Access Compliance Report

Public Rights-of-Way

(Curb Ramps)

Intersection ID: 12076	Main Street: N_CHURCH_ST	Cross Street: W_5TH_ST	Location: N
ADA ID: E00E4F911BFD	Ramp Type: Perp	Initial Pass/Fail: Fail	Overall Compliance: No
			Severity Score: 47.5
Codes/Mitigation Info/Possible Solution		Field Measurements/Component Compliance

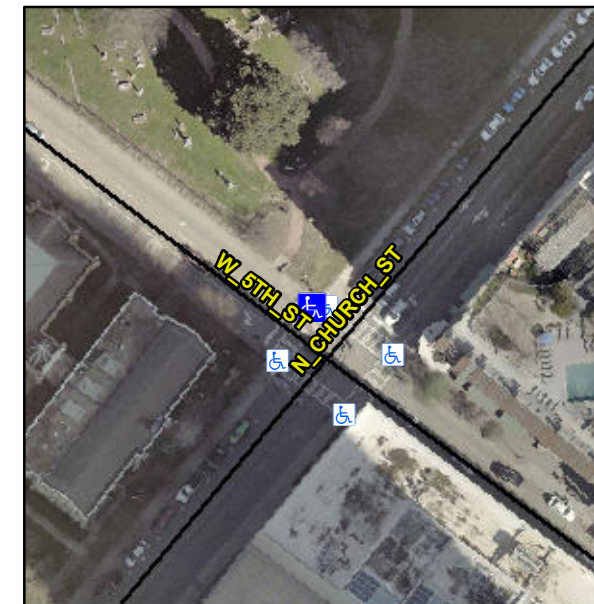
Not Found, R304.5.1, R304.2.2

Compliance	Description	Data	Compliance	Description	Data
N/A	Ramp Length (in)	58.0	No	Ramp Slope (%)	9.8
No	Ramp Width (in)	31.0	Yes	Ramp XSlope (%)	1.0
N/A	Flare Type LT	N/A	N/A	Flare Type RT	N/A
N/A	Flare Slope LT (%)	N/A	N/A	Flare Slope RT (%)	N/A
N/A	Flare Traversable LT?	N/A	N/A	Flare Traversable RT?	N/A
N/A	Landing Length (in)	N/A	N/A	DWS Provided?	N/A
N/A	Landing Width (in)	N/A	N/A	DWS Contrast?	N/A
N/A	Landing Slope (%)	N/A	N/A	DWS Length (in)	N/A
N/A	Landing X Slope (%)	N/A	N/A	DWS Full Width?	N/A
N/A	Landing Curb? (Y/N)	N/A	N/A	DWS Offset (in)	N/A
N/A	Shared Landing?	N/A			
N/A	Gutter Ponding?	N/A	N/A	Gutter Slope (%)	N/A
N/A	Gutter Lip Ht (in)	N/A	N/A	Gutter X Slope (%)	N/A
N/A	Painted X Walk1?	Yes	N/A	Painted X Walk2?	N/A
	X Walk 1 Direction	To SW		X Walk 2 Direction	N/A
N/A	X Walk 1 Width (in)	118.0	N/A	X Walk 2 Width (in)	N/A
	X Walk 1 Slope (%)	6.6		X Walk 2 Slope (%)	N/A
	X Walk 1 X Slope (%)	0.8		X Walk 2 X Slope (%)	N/A

Remove & Replace Entire Ramp.
